HIGHWAY 16 CLINICS
 STATE ROAD 16
 LA CROSSE, WISCONSIN
 UTILITY PLAN

C400

Amended Live Well Chiropractic Clinic Utility Plan March '26

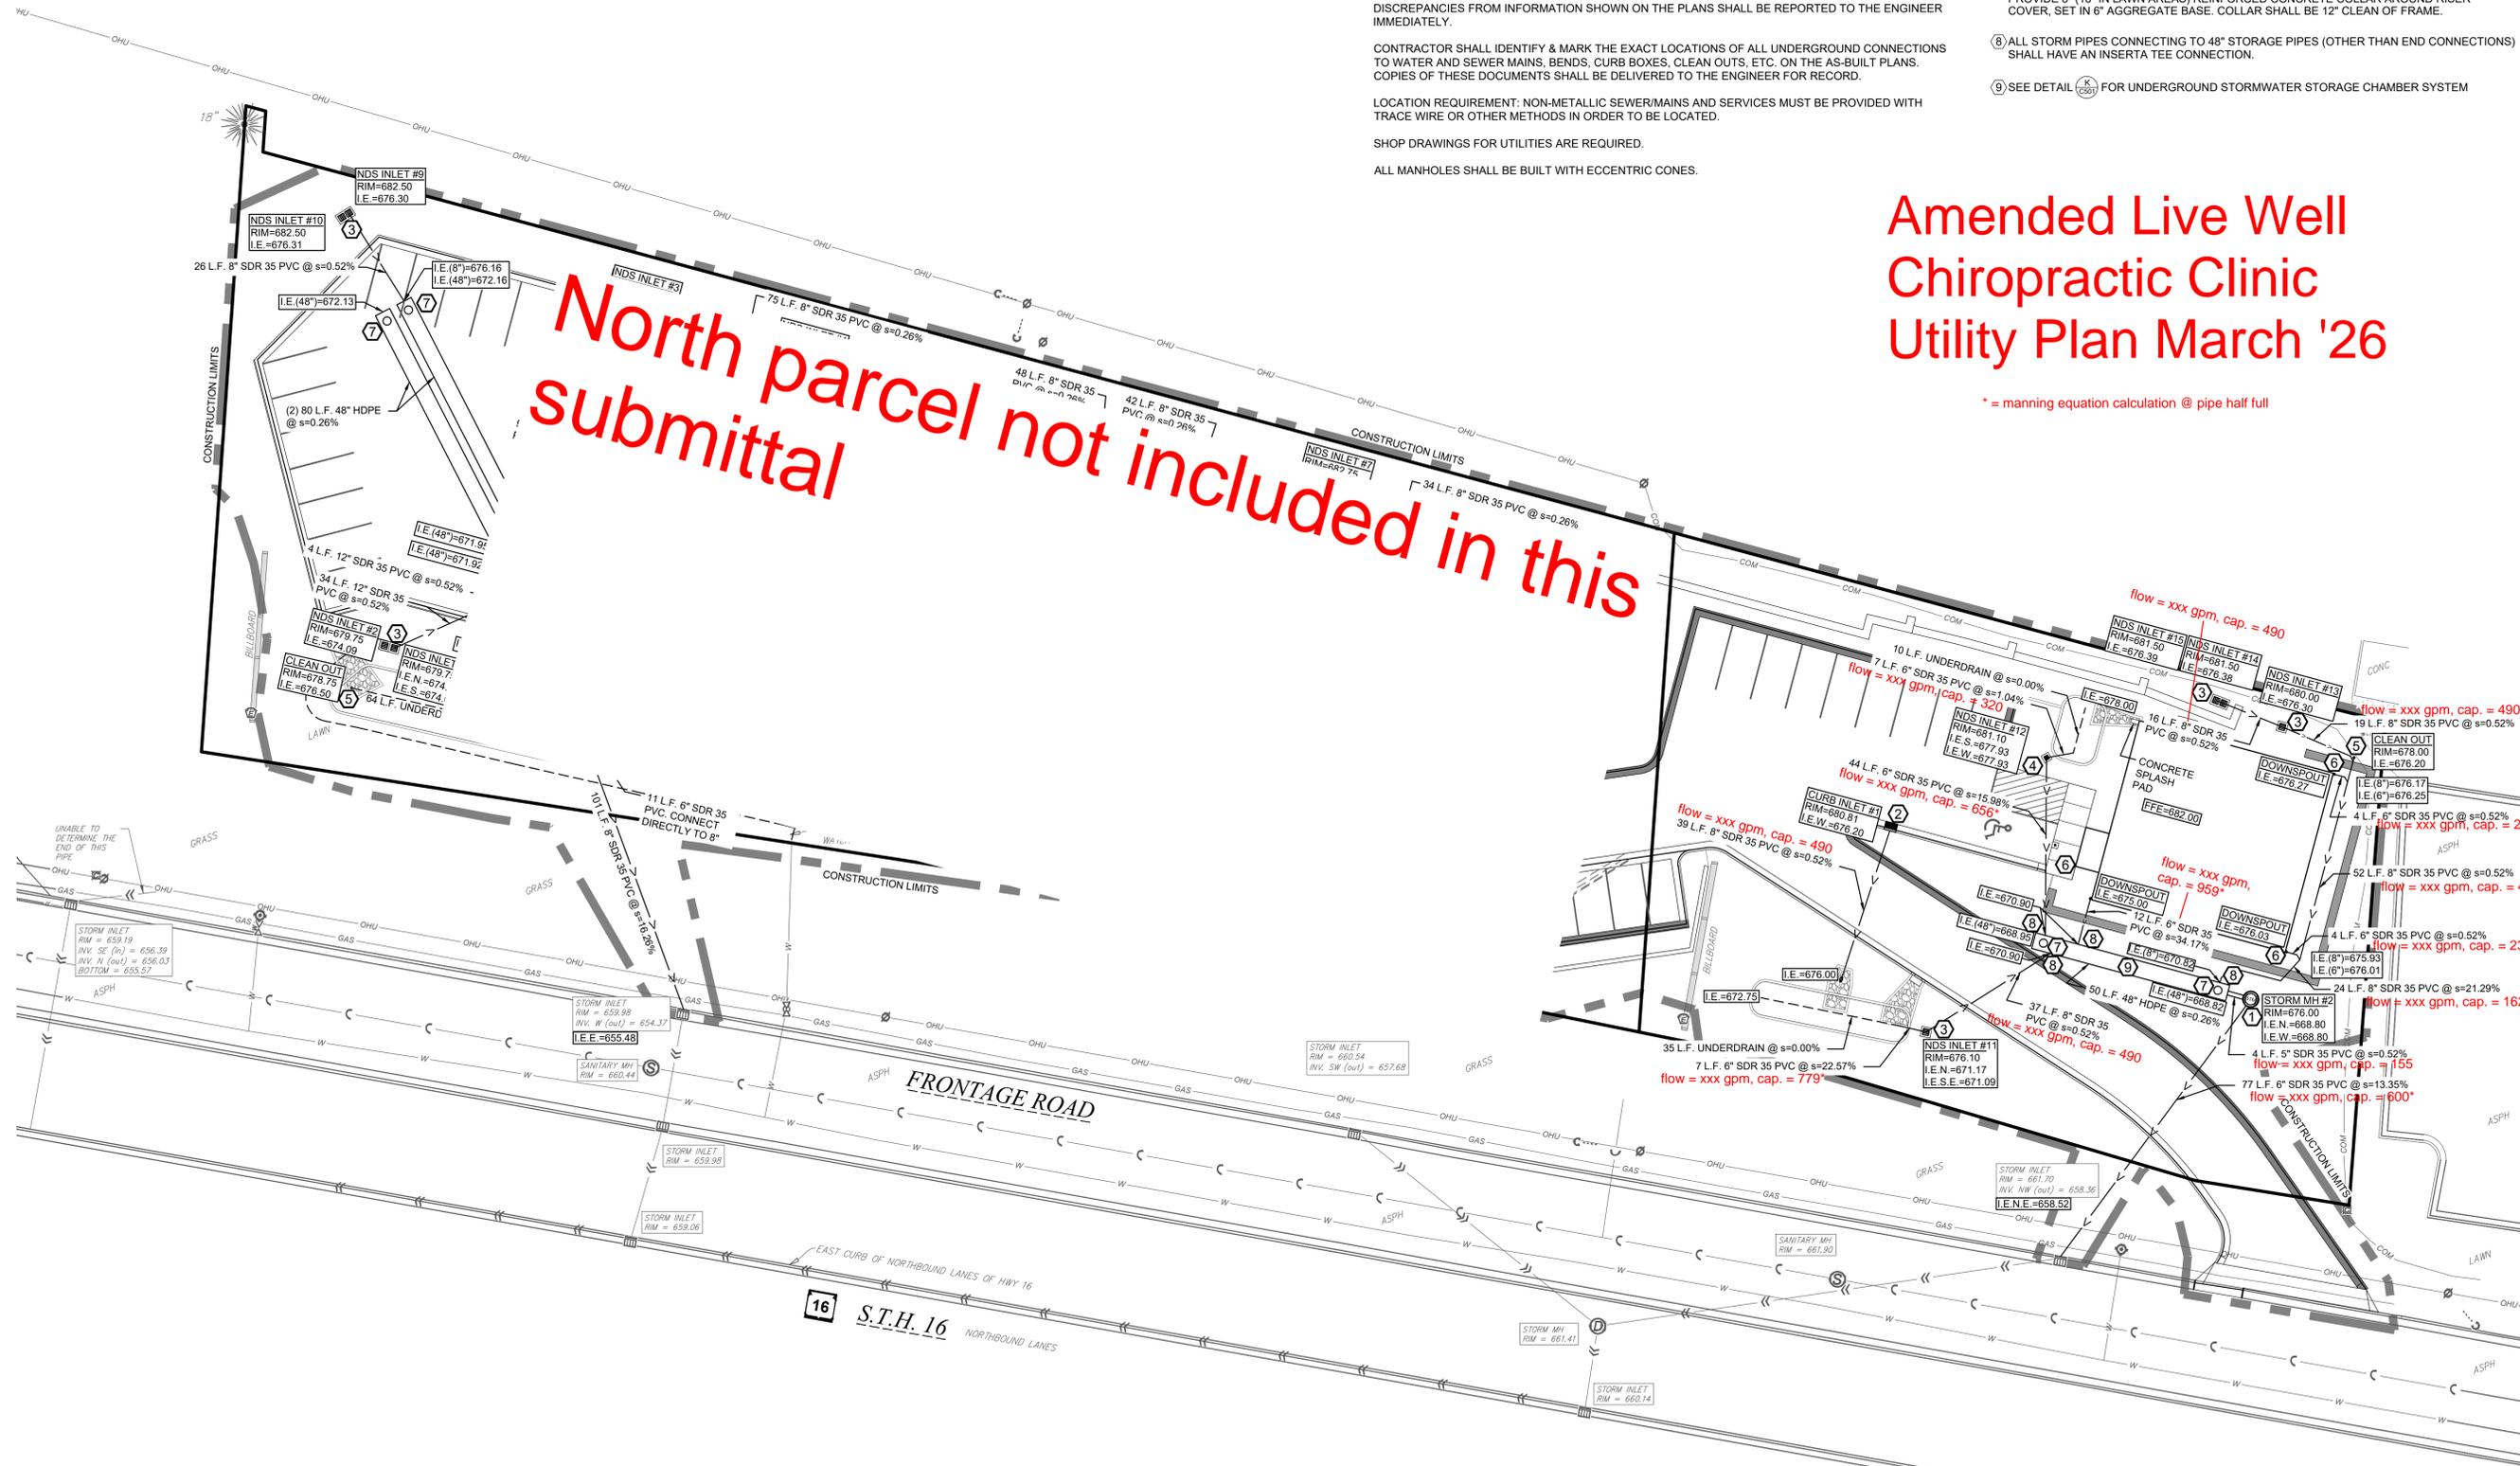
- CONSTRUCTION BULLETIN #1**
- NDS INLET #12 ELEVATION CHANGE
 - NDS INLET #11 RIM ELEVATION CHANGE
 - BIOFILTER #2 SIZE CHANGE AND CORRESPONDING PIPE LENGTHS
- CONSTRUCTION BULLETIN #2**
- NDS INLET #1 CONNECTS TO 48" PIPE (AND CHANGE IN 12" PIPE LENGTH)
 - INVERT CHANGES TO NDS INLETS #1 & #2 AND STORM MH #1
 - NDS INLET #13 AND DOWNSPOUTS CONNECT TO 48" PIPE (AND CORRESPONDING PIPE LENGTHS)
 - INVERT CHANGES TO STORM MH #2
 - ADD HEX NOTE #8
- CONSTRUCTION BULLETIN #4**
- ADD HEX NOTE #9
- CONSTRUCTION BULLETIN #5**
- UNDERGROUND STORAGE SYSTEM ON SOUTH SITE SHIFTED SOUTHWEST TO ACCOMMODATE INCREASED SIZE OF BUILDING. INVERTS AND PIPE LENGTHS ADJUSTED FOR NEW LOCATION OF SYSTEM.
